Planning Reference Number 2023/1357/P

We have revised this Cover Letter with updated drawing numbers. We've tried, very hard, to submit this MMA in a valid format. We think that the attached Schedule of Changes, adequately captures all of the proposed changes. In addition, we are resubmitting this Cover Letter, which explains in more detail than we could put on drawings or schedule, the changes to the services, staircase and landings, which cumulatively which led us to changes in the Roof Terrace access and width. (Schedule Item 7, 8, 9, 12, 13, 14, 15).

Image 1 - Approved Scheme – Staircase Width

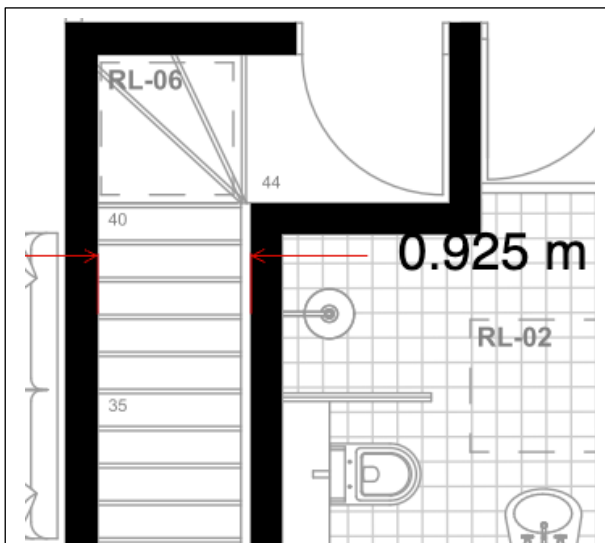
- Non-compliant Staircase** - The common staircase within the 'As Approved' Design was not wide enough, falling short of Building Regulations Requirements. This has been addressed in the new design. The stair width is now 1000mm wide (excluding handrails).
 - 3.60** *A stair of acceptable width for everyday use will be sufficient for escape purposes. If it is also a firefighting stair, it should be at least 1100mm wide. The width is the clear width between the walls or balustrades. Any handrails and strings intruding into that width by a maximum of 100mm on each side may be ignored.*

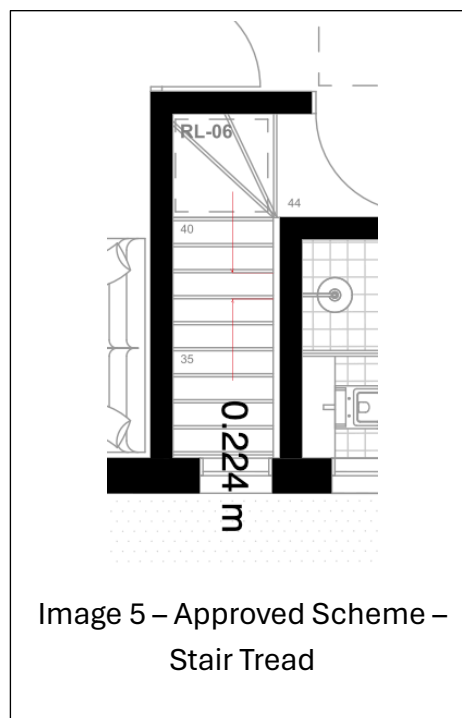
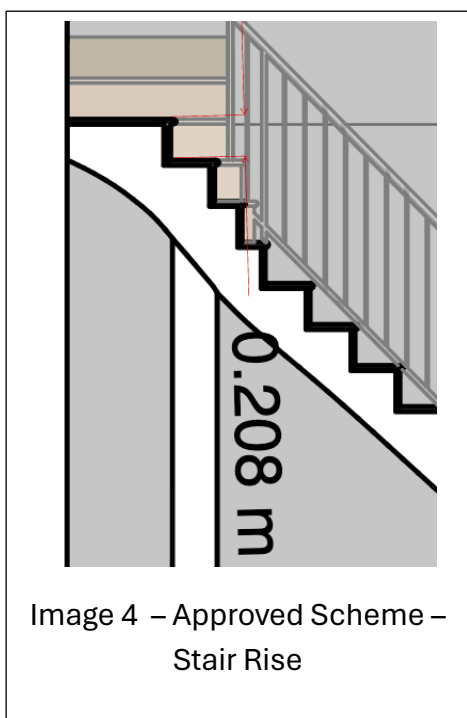
- Rise and Going to the communal stairs were not compliant. Risers have been made smaller and the going has been increased, resulting in additional stairs. Please refer to Images 4 and 5.
 - **1.3** In a flight of steps, for all steps use the measurements for rise and going given for the three stair categories in Table 1.1. Use any rise between the minimum and maximum with any going between the minimum and maximum, that complies with the relevant note contained in table 1.1.
